HISTORIC LANDMARK COMMISSION
PERMITS IN NATIONAL REGISTER HISTORIC DISTRICTS
MARCH 23, 2015
NRD-2015-0014
1708 W. 30th Street

PROPOSAL

Construct a 2nd story addition to a contributing house; demolish existing sunroom addition and replace with extended living area.

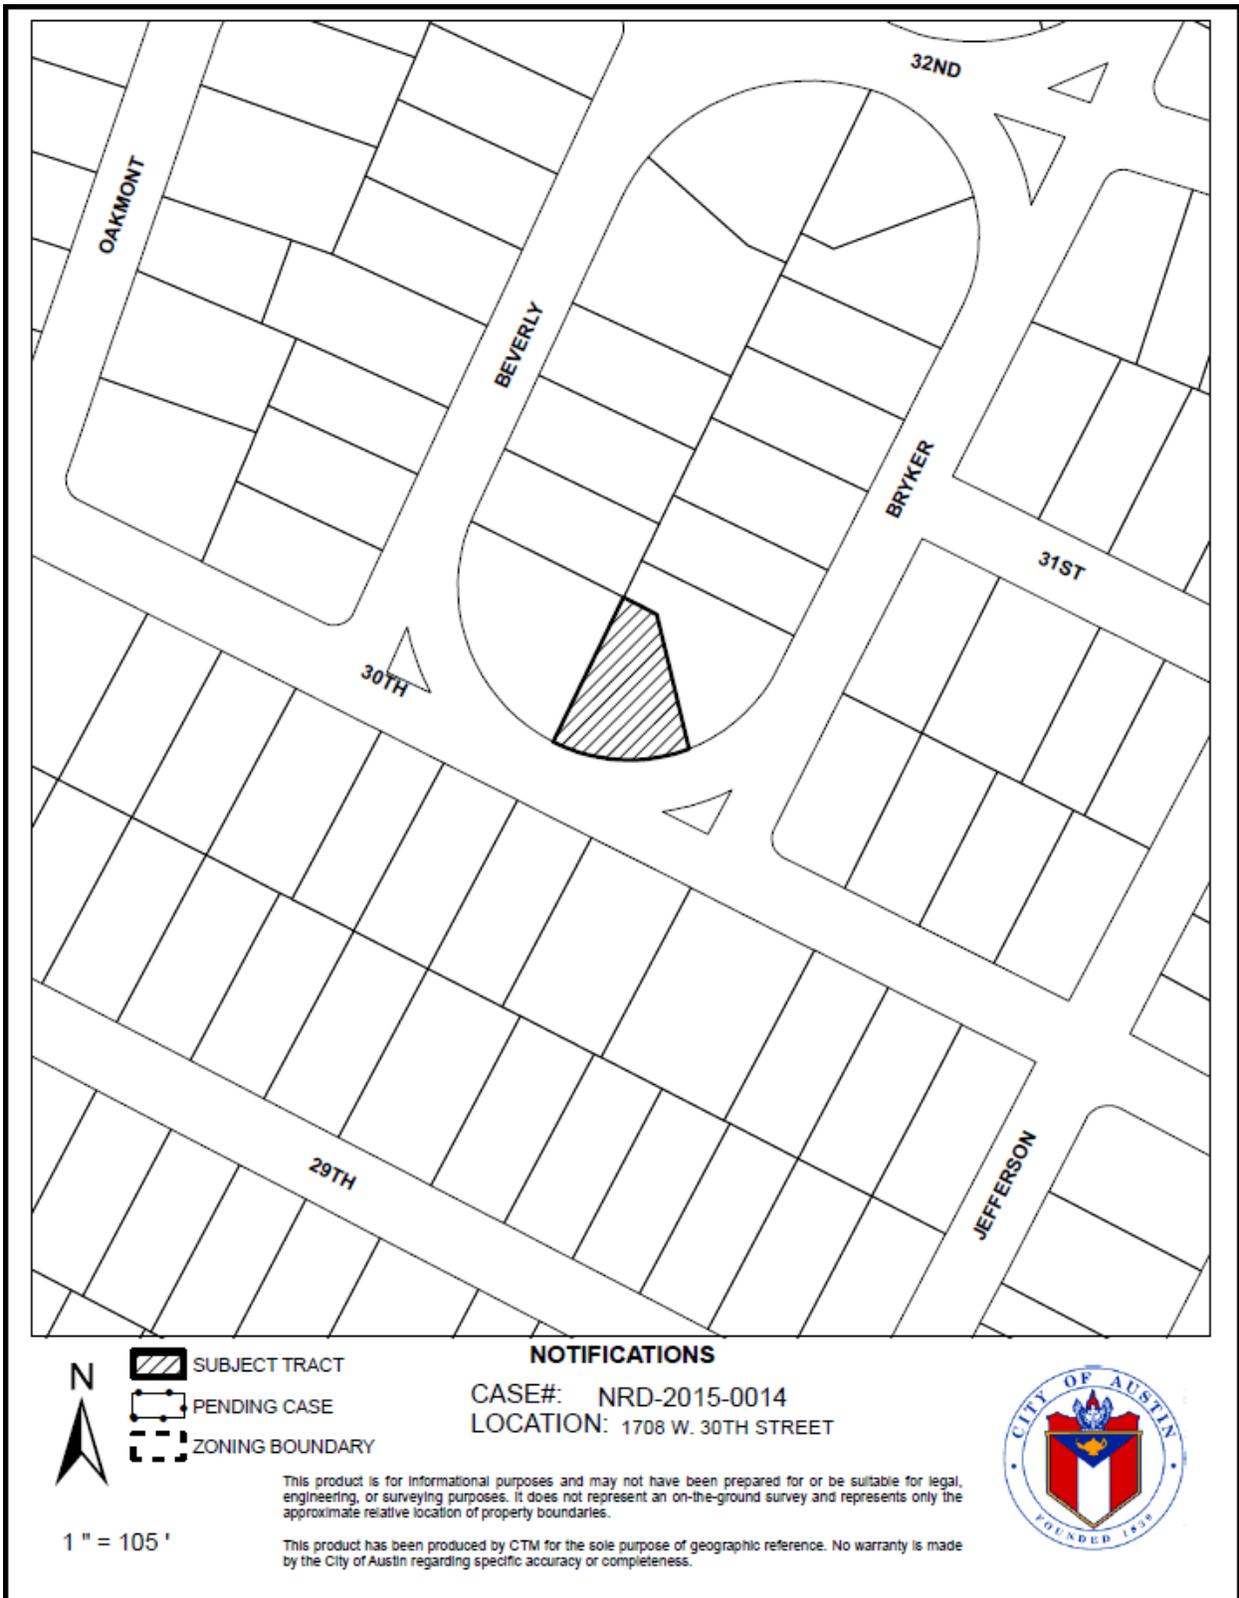
The house is a very good example of the International Style on a relatively modest scale. Further, the house is constructed of clay tile, and the original owner of the house, Professor Wayne E. Long of the University of Texas, had published a pamphlet on the thermal characteristics of ceramic walls, and was an expert in thermoscience, air conditioning, and environmental engineering. Staff applauds the applicant for keeping the original materials of the house, as they possibly represent an innovation in building materials that the first owner championed in keeping a house cool in Austin's climate.

The proposed addition is far too tall and overwhelming for this house, and should be scaled back in terms of height and placement on the house; the applicant should also consider a fenestration patterns more compatible with the International Style fenestration on the existing house. Staff recommends reducing the height of the addition, and considering a different fenestration pattern for the proposed addition, as well as pulling the front of the addition back as far as possible from the front of the house, and to complete a City of Austin Documentation Package consisting of photographs of all elevations, a dimensioned sketch plan, and a narrative history, prior to release of the permit.
